**PROJECT:** Merced College Greenhouse Complex

**BID NO:** 2024-08  
**BCF PROJECT NO.** 222-0314

REF. & REV.  
BIDDING  
ADDENDUM 01

MERCED COLLEGE GREENHOUSE COMPLEX  
GREENHOUSE COMPLEX  
SITE PLAN & HORIZONTAL  
CONTROL  
CONST. DOCUMENTS  
C104

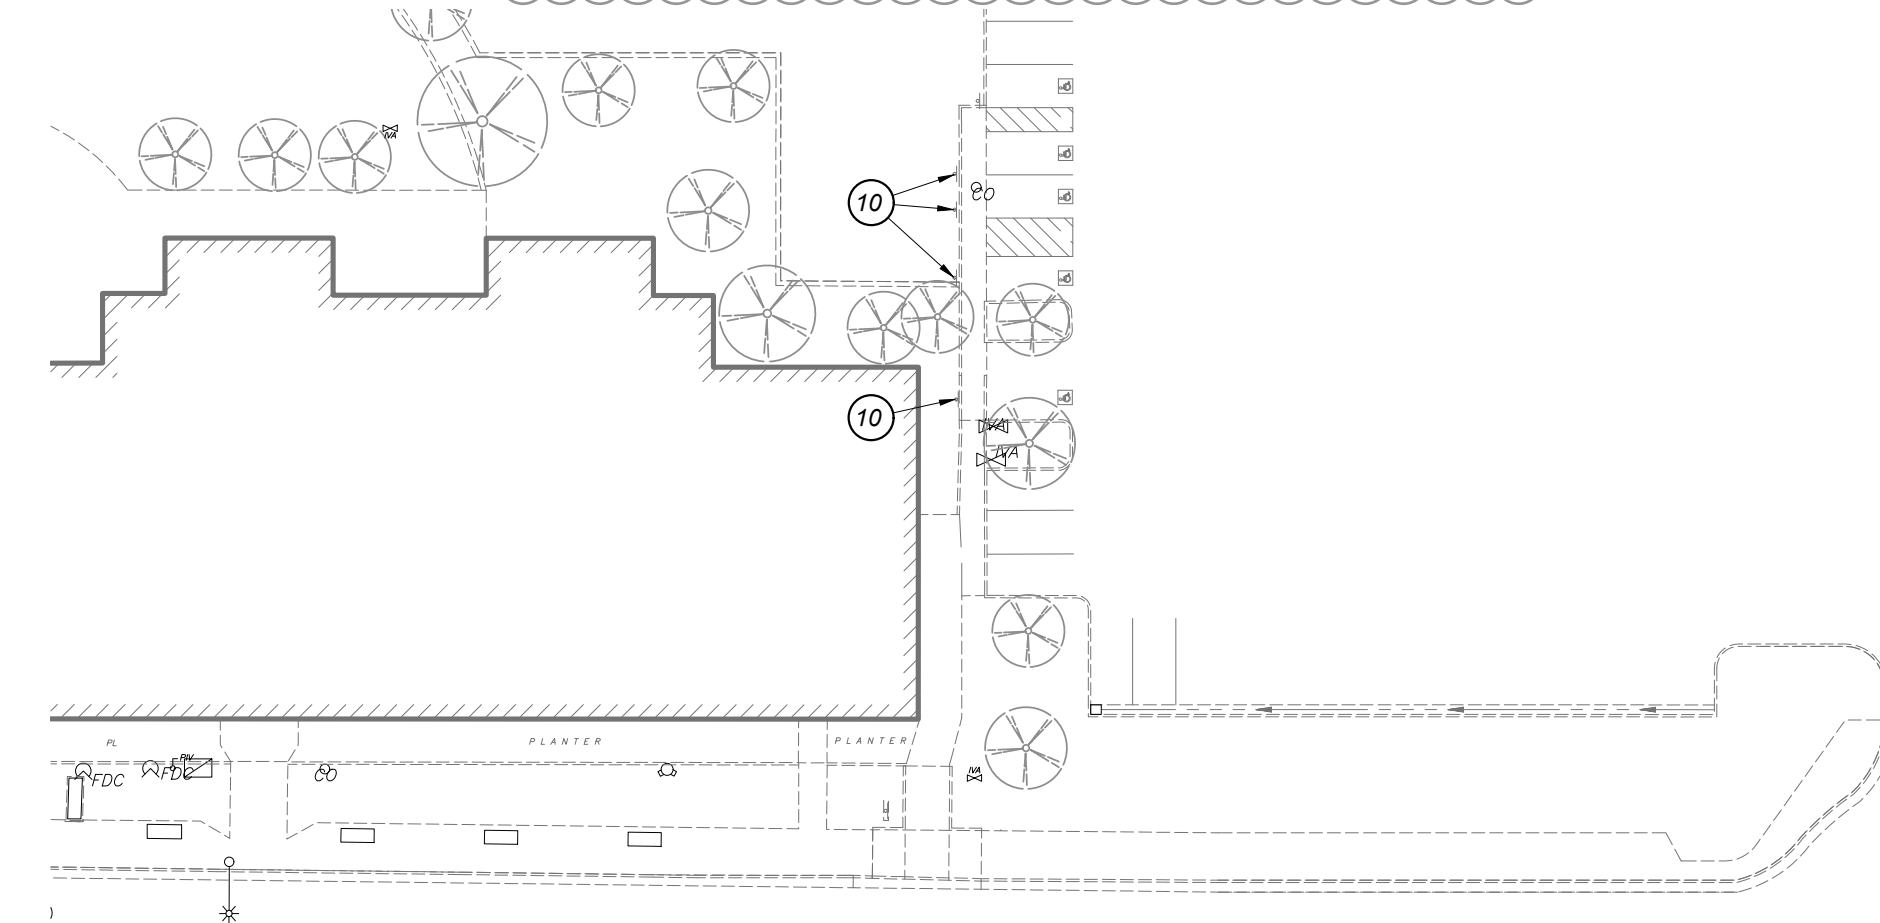
1. Deductive Alternate 1 has been added to sheet C104
2. Deductive Alternate 2 has been added to sheet C104

- CONCRETE & UTILITY SCOPE REDUCTION  
A. REMOVE CONCRETE SIDEWALK FROM SCOPE THAT IS SHOWN IN GREEN. MAINTAIN CONCRETE SIDEWALK SHOWN IN RED.  
B. REMOVE TRENCH FROM SCOPE  
DEDUCTIVE ALTERNATE 1 NOTE: IF DEDUCTIVE ALTERNATE IS ACCEPTED, CONTRACTOR SHALL MAINTAIN DRAINAGE PATTERNS AS IDENTIFIED IN THE DESIGN DOCUMENTS
- FENCE SCOPE REDUCTION  
REMOVE FENCE INSTALLATION FROM SCOPE
